BIA – AUDIT QUERY TRACKER.

**4 THE GROVE,
HIGHGATE, LONDON
N6 6JU**

ADDITIONAL AUDIT QUESTIONS – DATED MAY 2024.

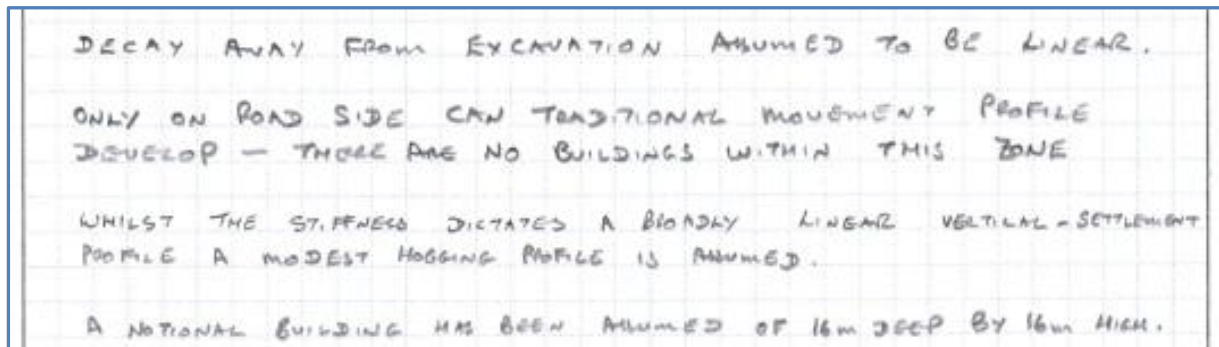
The zone of influences assumed for the installation of the retaining wall and excavation of the basement should be clearly presented and the impact of any structures or relevant assets within the ZoI should be clearly identified. I'm not sure why a 'notional building' has been included in the assessment; does this relate the host building? If so, could they provide some clarification. Please note that the ZoI should be considered the full length of the piles and the maximum depth of the basement excavation.

Settlements associated with the installation of the piles and the basement excavation have been added to an updated drawing - Heave Profile + Construction Settlements 073-TCE-XX-LG-D-S-098 (P2) as has the zone of influences. The calculations on which the Pile Installation Settlement is based are included in Appendix A of this document. Calculations predicting the Basement Excavation Settlements were submitted previously, in Appendix A of the BIA.

From this drawing, it can be seen that there are no buildings within the ZoI hence the use of the "Notional Building for Context".

DECAY AWAY FROM EXCAVATION ASSUMED TO BE LINEAR.
 ONLY ON ROAD SIDE CAN TRADITIONAL MOVEMENT PROFILE DEVELOP - THERE ARE NO BUILDINGS WITHIN THIS ZONE
 WHILST THE STIFFNESS DICTATES A BROADLY LINEAR VERTICAL SETTLEMENT PROFILE A MODEST HOGGING PROFILE IS ASSUMED.
 A NOTIONAL BUILDING HAS BEEN ASSUMED OF 16m DEEP BY 16m HIGH.
